Project Address: 1411 S. Potomac St. Unit # 400 Zip code: \_\_\_\_\_  
Project Name: Colorado Orthopedic Consultants  
Contractor Company Name: TBD Phone: \_\_\_\_\_ Fax: \_\_\_\_\_  
Contact Person: \_\_\_\_\_ Phone: \_\_\_\_\_  
Email: \_\_\_\_\_ Fax: \_\_\_\_\_

Tenant Improvement Build-out Colorado  
Orthopedic Consultant

RSN: 619637  
Permit #: 2011558118

Reflected  
Ceiling Plan

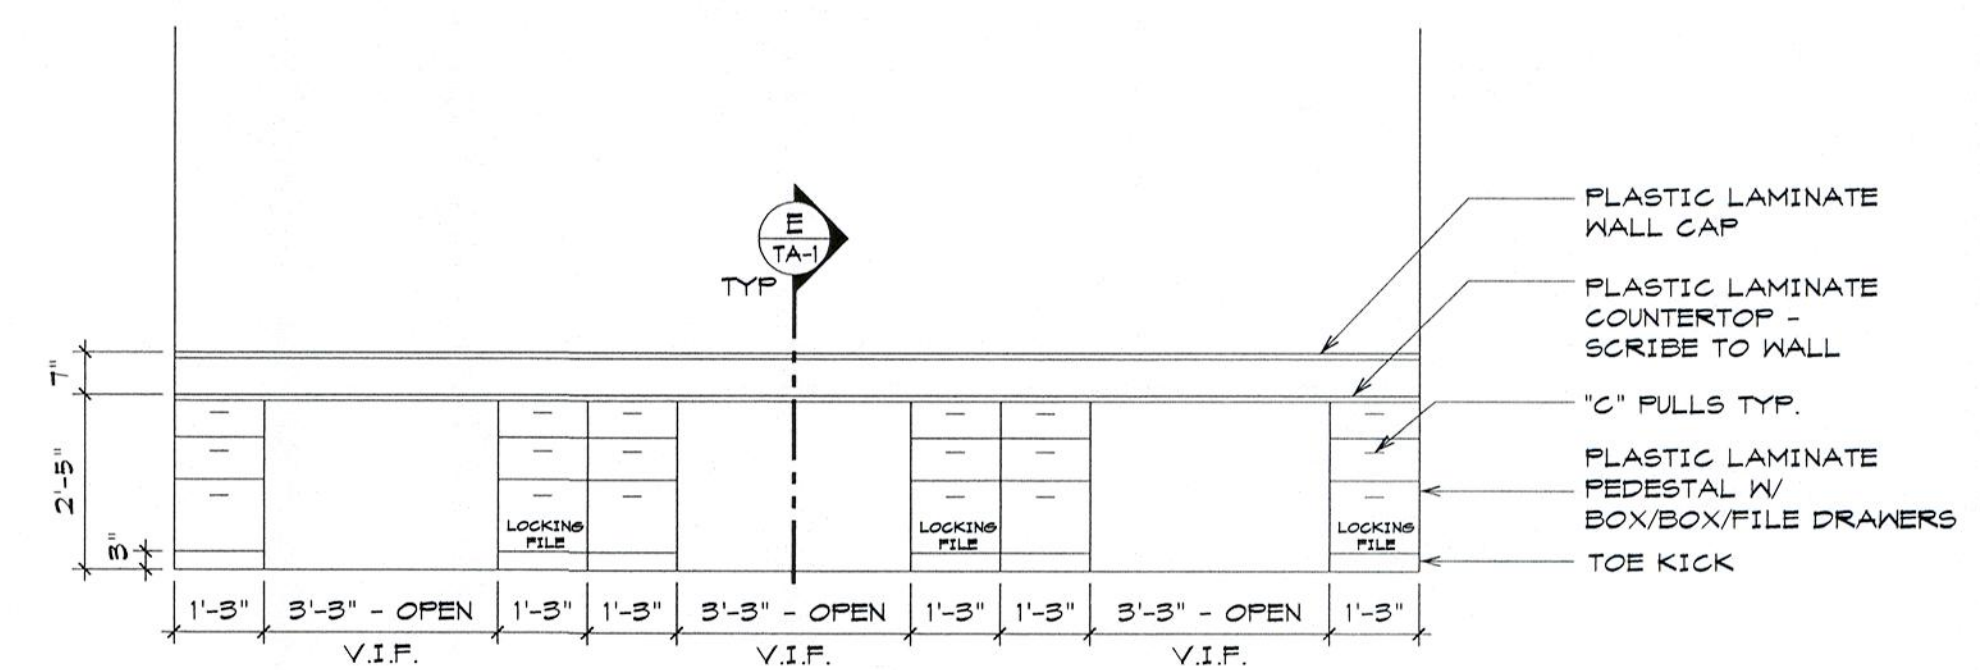
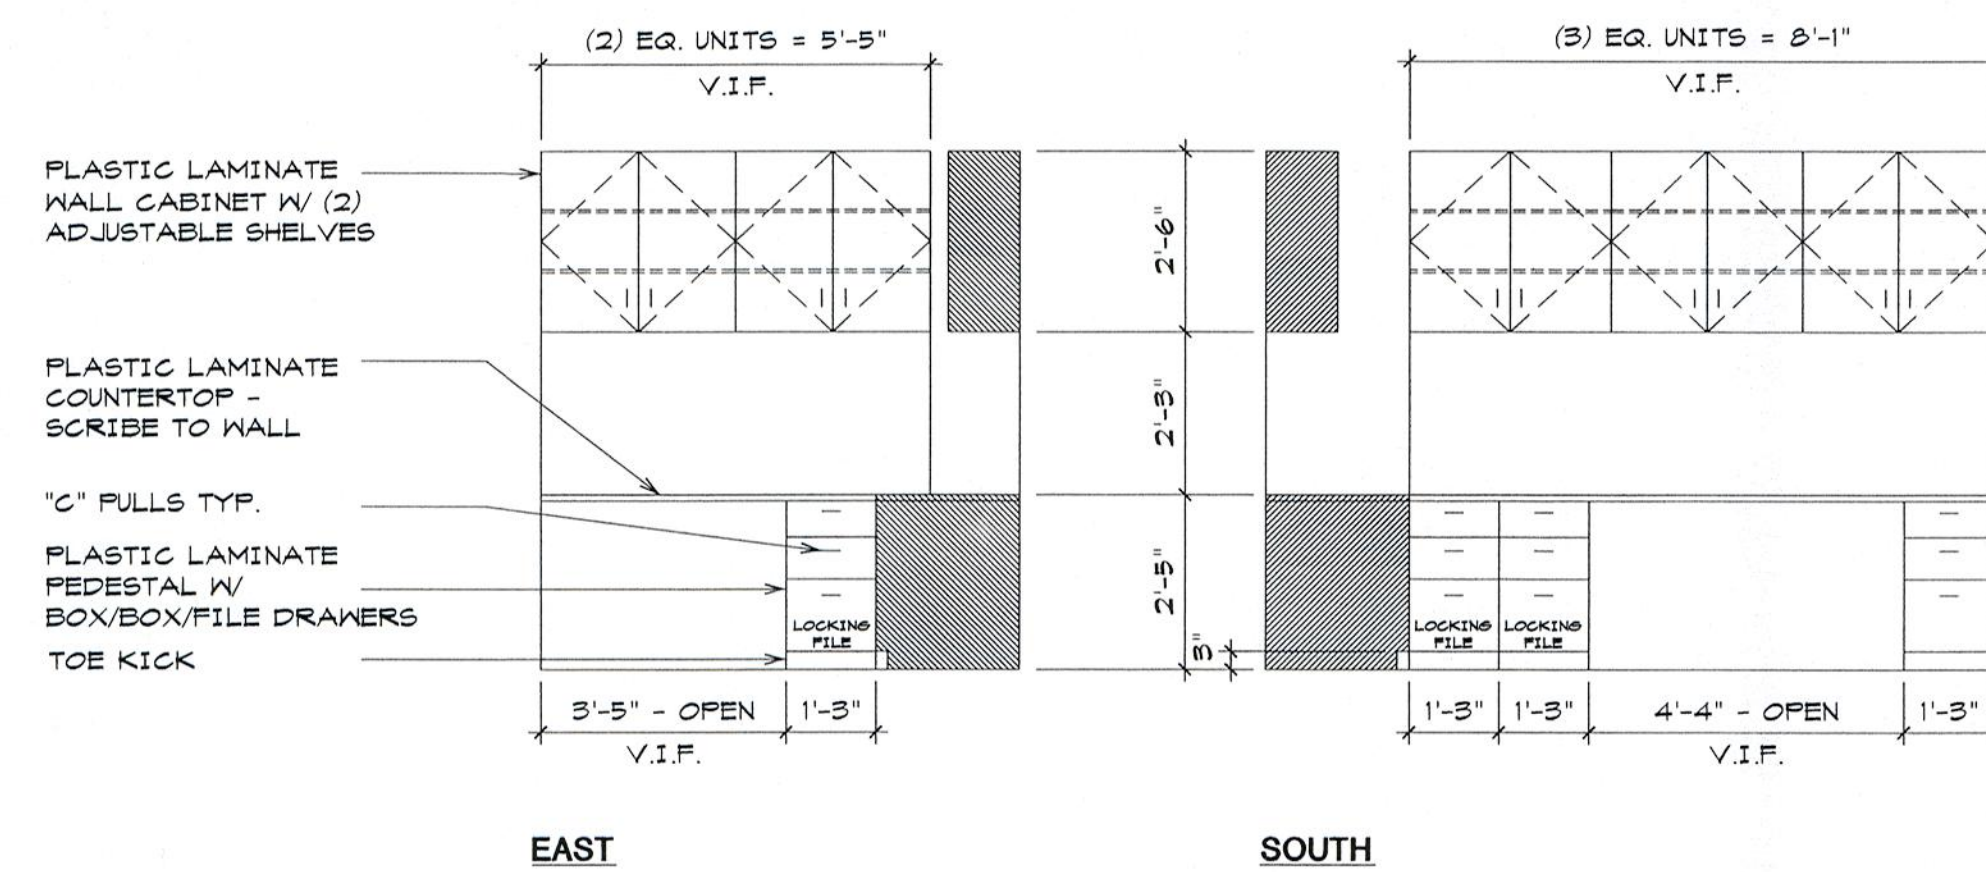
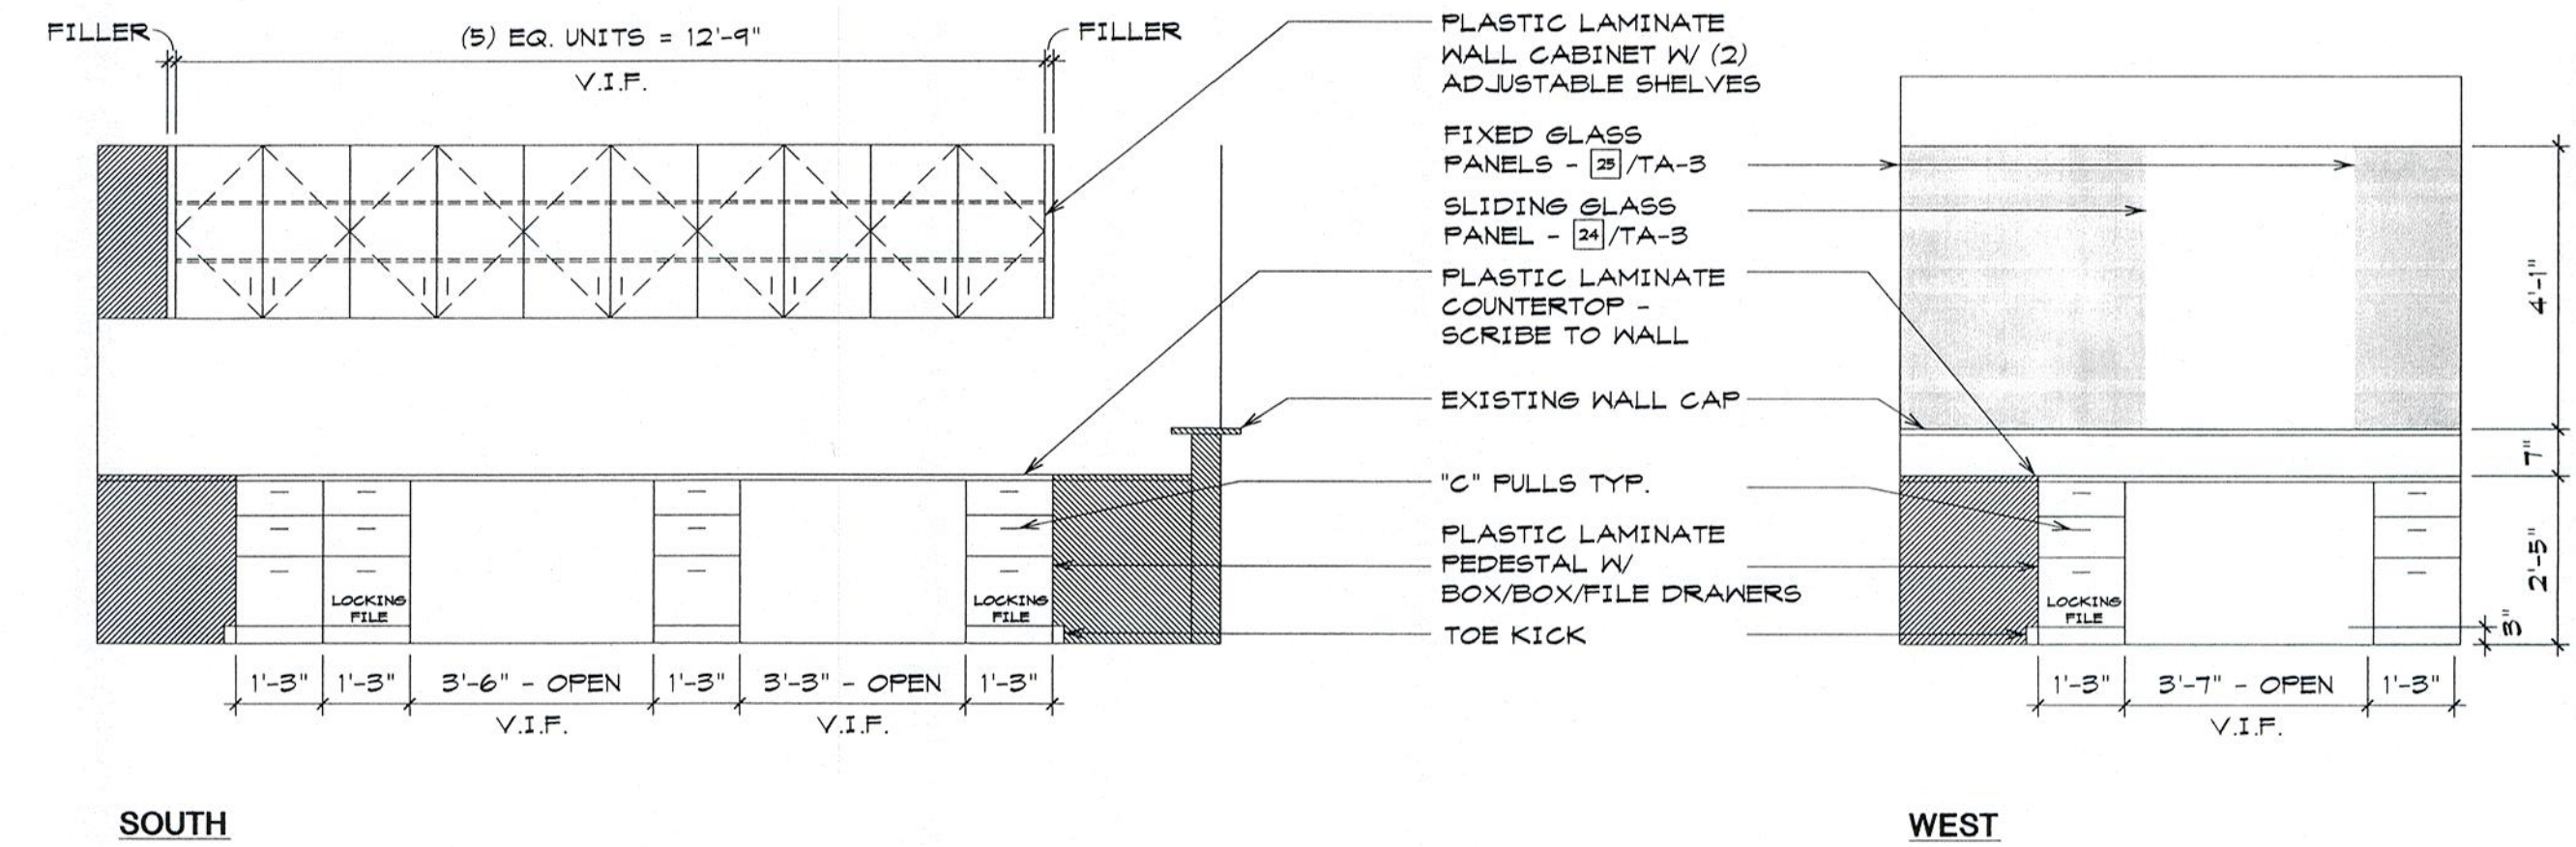
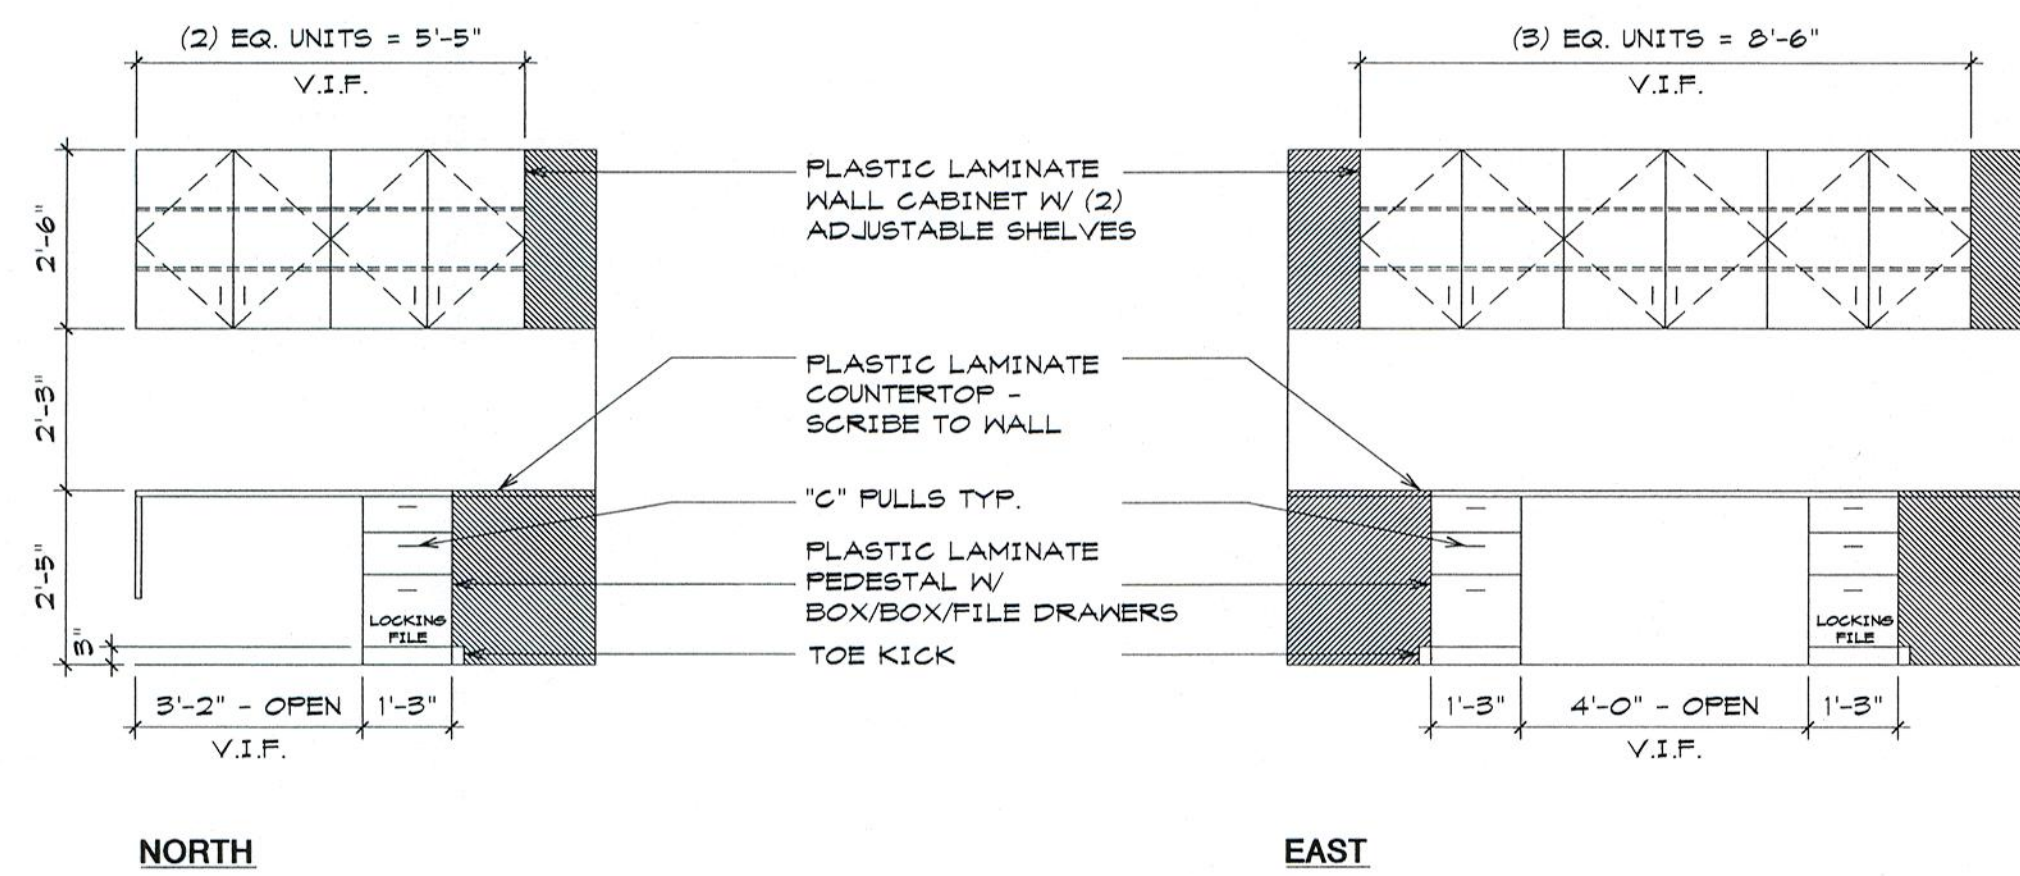
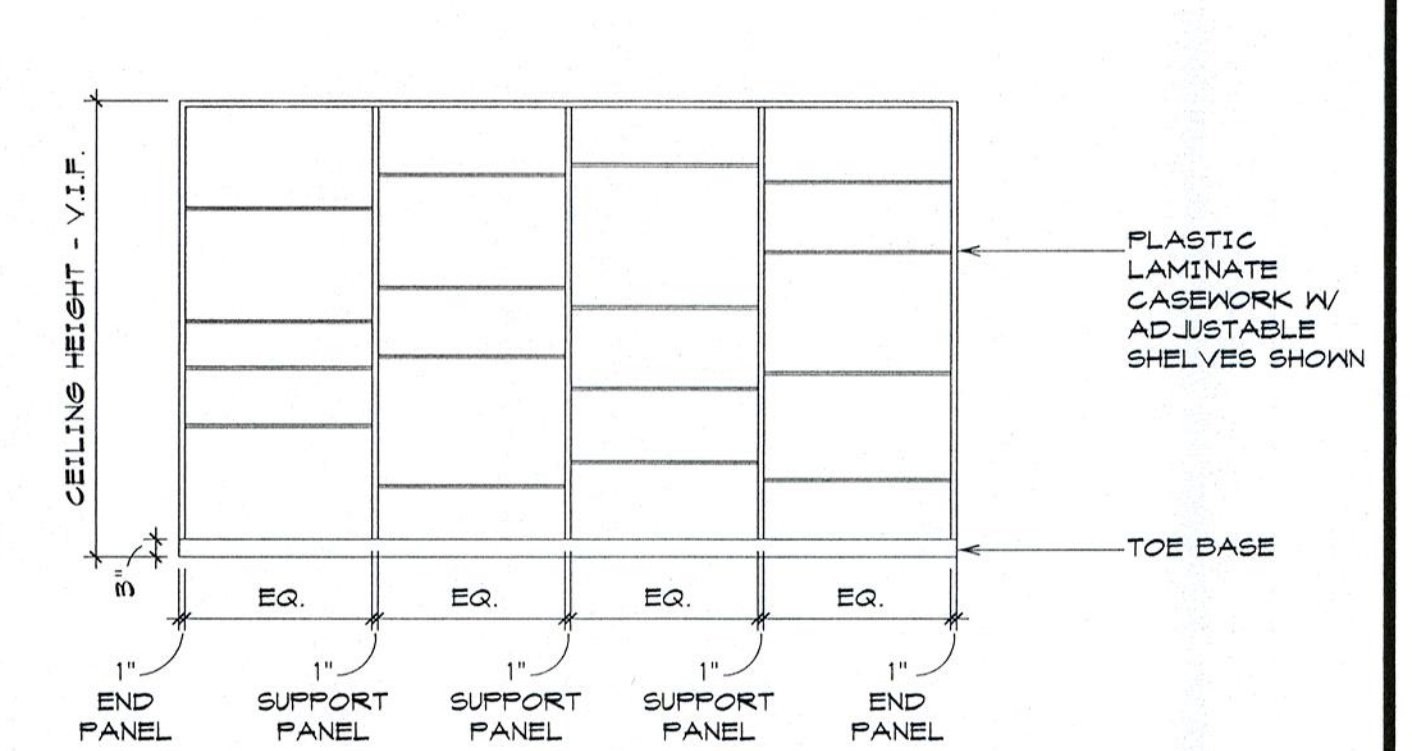
After hours inspection to verify required gross illumination may be required during field inspection. 2009 IBC 1006
